CITY OF WORCESTER, MASSACHUSETTS

Shrewsbury Street Sewer Rehabilitation Sewer Rehabilitation Project  
Contract S24-1-ARPA  
Bid No. 8180-W4

ADDENDUM NO. 1

To be considered as part of the contract drawings and specifications for the Shrewsbury Street Sewer Rehabilitation Sewer Rehabilitation Project, dated April 2024:

**Sheet C102**

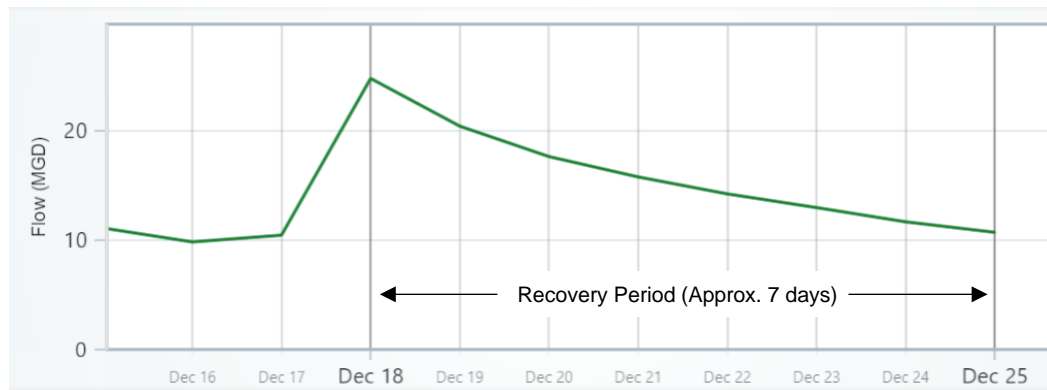
1. Geopolymer Lining of Sewers is changed to Epoxy Lining of Sewer. See SK-2 for the revision.
2. The overflow pipe at manhole SS07502 is 24-inch in diameter. See SK-1 for a sketch of the revision.

Graph 1 - Average Daily Flow From 12/15/23 to 12/25/23

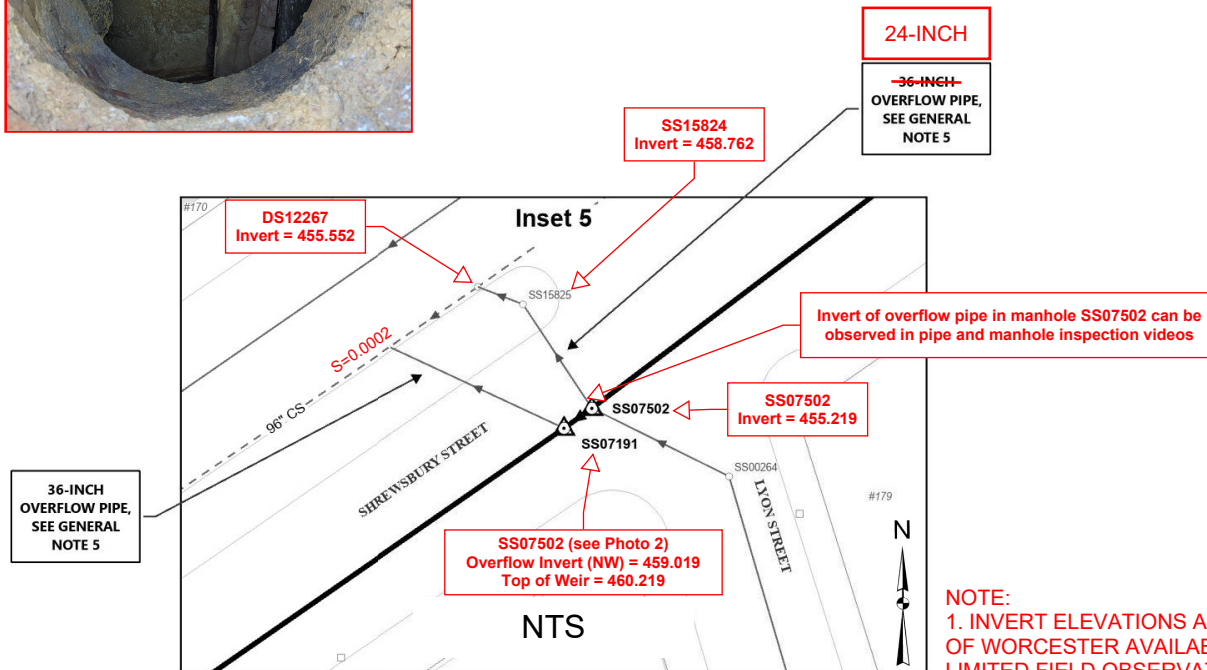
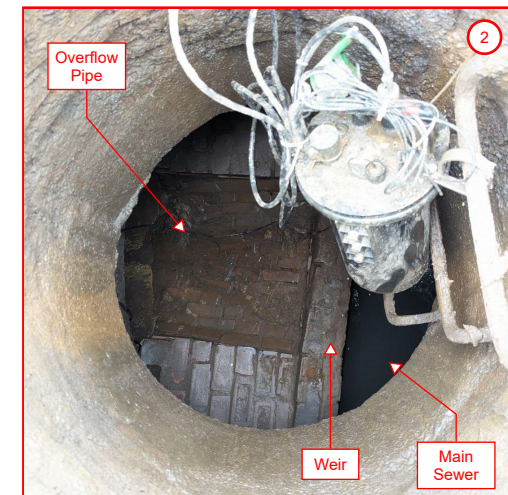
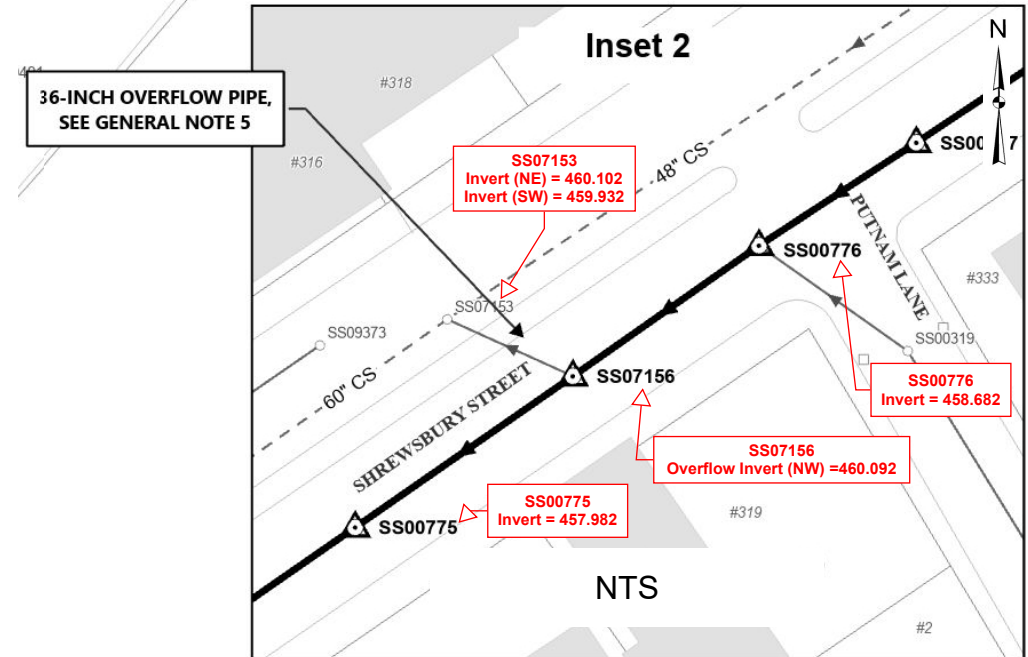
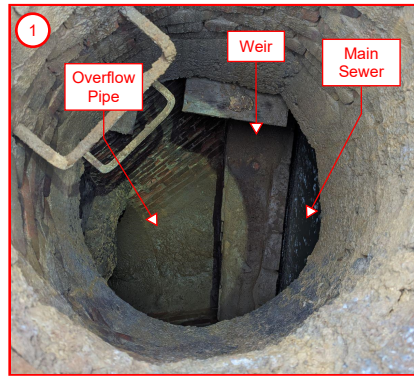
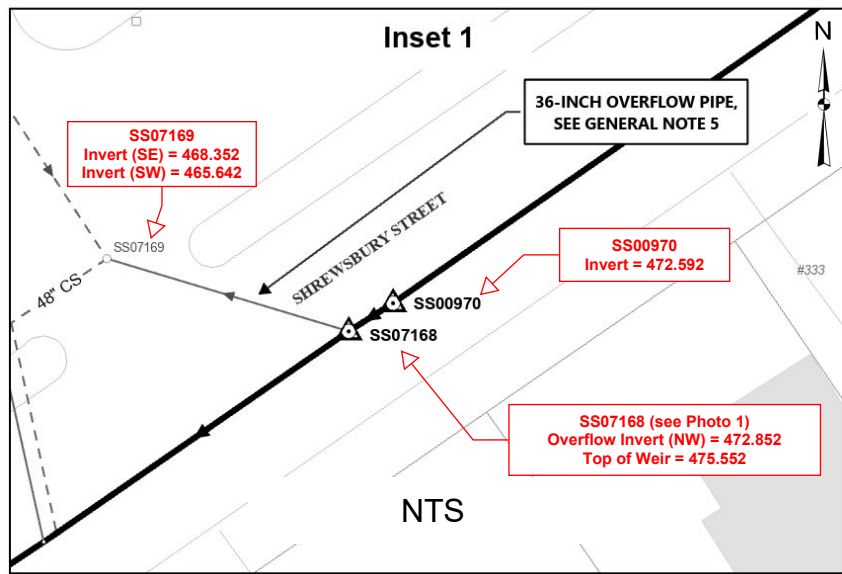
- Q1. The capacity of the system and the dry weather flows have a large variance - what are the flows that the bypass system should be designed for?
- A1. **The design, installation, and operation of the temporary bypass pumping system shall be the Contractor's responsibility. It should be noted that the sewers in the project area are part of a combined system. Flow volumes are dependent on weather events and may take several days to subside following an event. Bypass pumping systems shall have sufficient capacity to pump all sanitary and combined sewer flows during liner installation and other related work. The Contractor may elect to release plugs during non-work hours.**

A rain gauge in the City recorded a peak hourly rainfall of 0.95-in on July 14, 2023, which was the highest recorded hourly intensity during the metering period. The peak flow recorded during the storm was approximately 61.5 MGD.

The largest 24-hour (1-day) storm occurred on December 18, 2023. A total of approximately 2.75 inches of rain was recorded. The peak flow recorded during that storm was 44.4 MGD. Prior to the storm, the average daily flow was approximately 10 MGD; however, the average daily flow did not subside after several days after the storm as seen in the graph on the following page. It should be noted that the graph on the following page shows the average daily flow each day, not the maximum instant peak, which is 44.4 MGD as stated above.

# SK-2

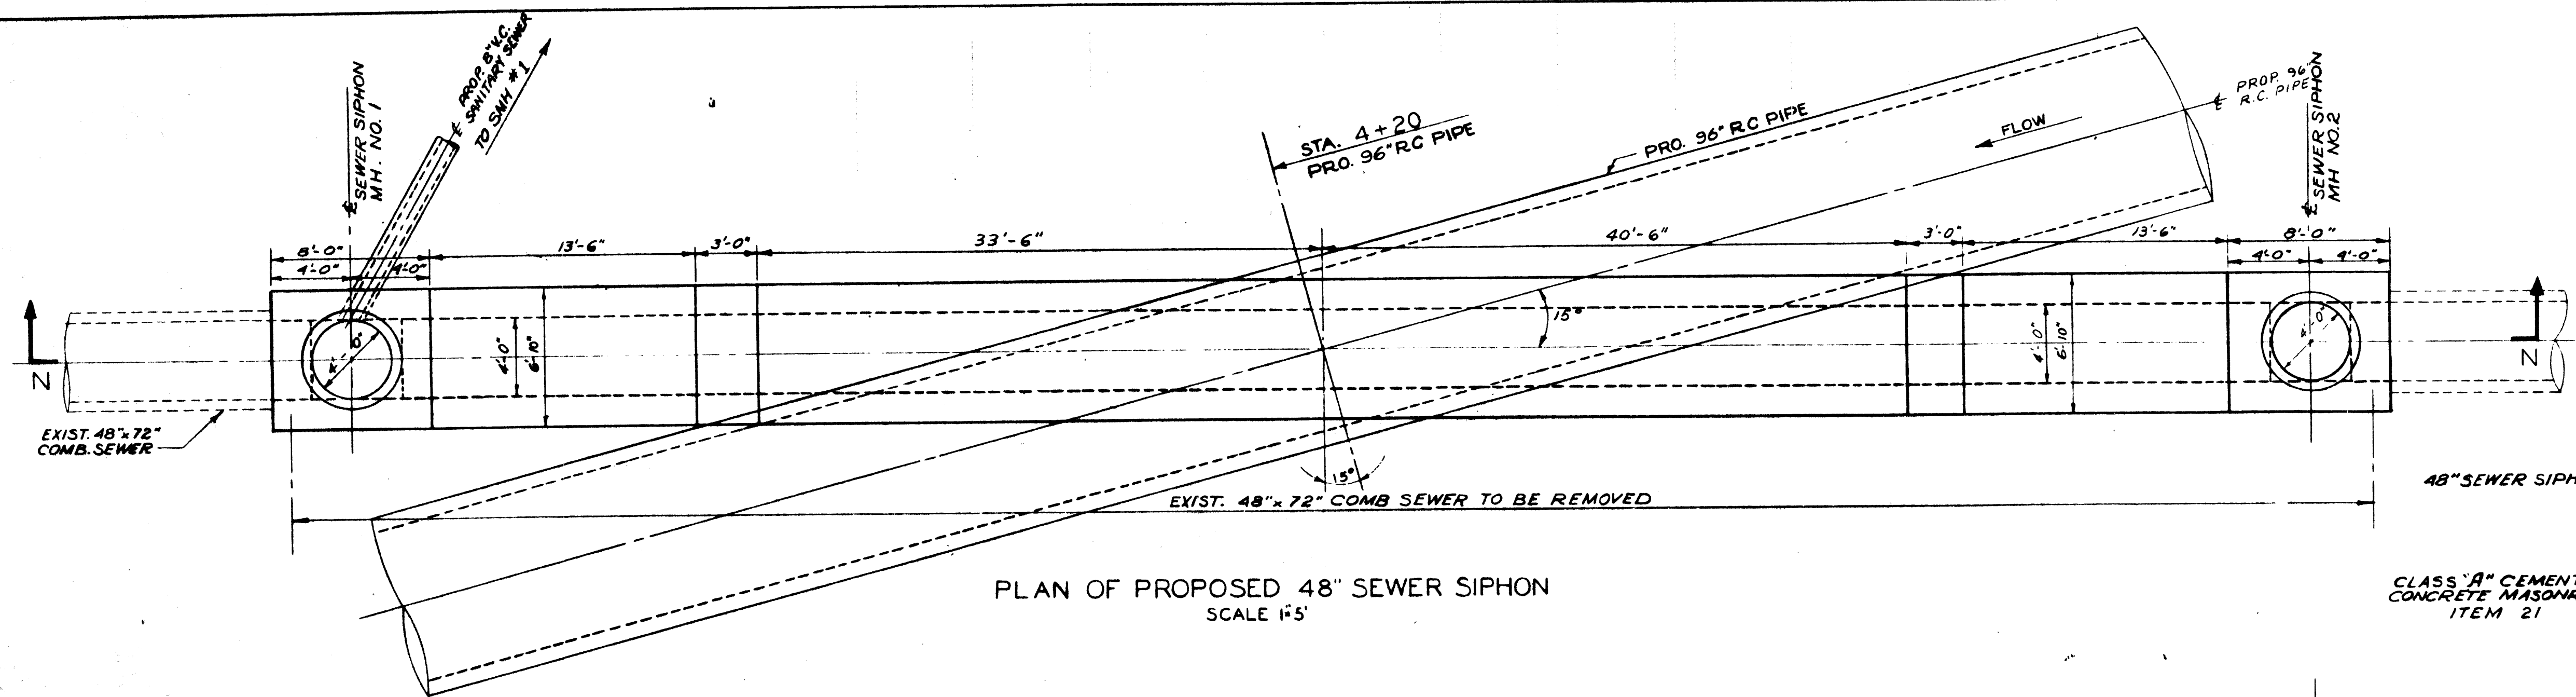
4. SERVICE CONNECTION STATION LOCATIONS BEGIN FROM UPSTREAM MANHOLE TO DOWNSTREAM MANHOLE, UNLESS OTHERWISE NOTED.
  5. ~~CONTRACTOR MAY ELECT TO UTILIZE OVERFLOW PIPES TO DIVERT FLOWS INTO THE 96-IN COMBINED SEWER BY INSTALLING PLUGS. CONTRACTOR SHALL SUBMIT A FLOW DIVERSION PLAN FOR APPROVAL PRIOR TO ANY DIVERSION OF FLOWS.~~

6. PAVEMENT REPLACEMENT SHALL BE PERFORMED ACCORDING TO THE CITY OF WORCESTER'S STANDARD SPECIFICATIONS AND DETAILS.
5. CONTRACTOR MAY ELECT TO UTILIZE OVERFLOW PIPES TO DIVERT FLOWS INTO THE 48-, 60-, 84-, AND 96-IN COMBINED SEWER BY INSTALLING PLUGS. CONTRACTOR SHALL SUBMIT A FLOW DIVERSION PLAN FOR APPROVAL PRIOR TO ANY DIVERSION OF FLOWS.

### EPOXY LINING OF SEWER

### ~~GEOPOLYMER LINING OF SEWERS~~

A6. **Yes. See attached SK-2 for revised General Note.**

A11. **See attached SK-2 for a sketch of a revision showing epoxy lining.**
